SERVICE TECHNICAL INFORMATION

ONE POINT REPAIR

REF. NO. : SI-97-019
CUSTOMER RELATION SERVICE DIV.

MODELS : Z-M2800/M2900/VM280/VM290, NSX-F9/V800/V900
SUBJECT : No power/Sound Distortion due to power IC defect.
CONTENTS : Due to power IC(STK-419-***defect, it is caused to no power or sound distortion. It requires to modify following contents to all repair items when replace in the above mentioned power IC.

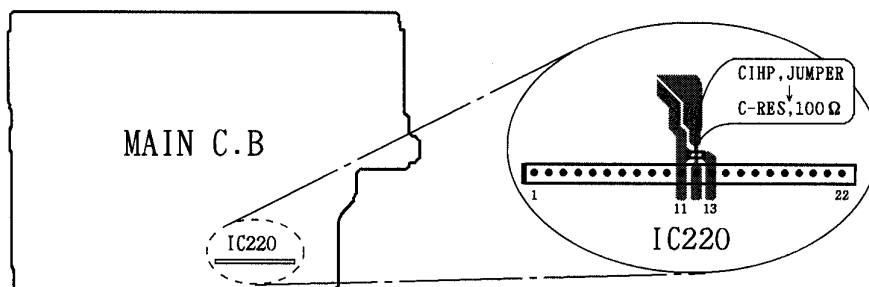
MEMO : This modification is required to do all in the above mentioned models for repair even power IC is not damaged.

REMEDY : To replace parts from chip jumper to chip resistor, $100\Omega \cdot 1/8W$, between pin① and ⑬ of IC220.

Ref.	PARTS CODE	PARTS NAME
	88-128-101-010	C-RES, 100Ω 1/8W
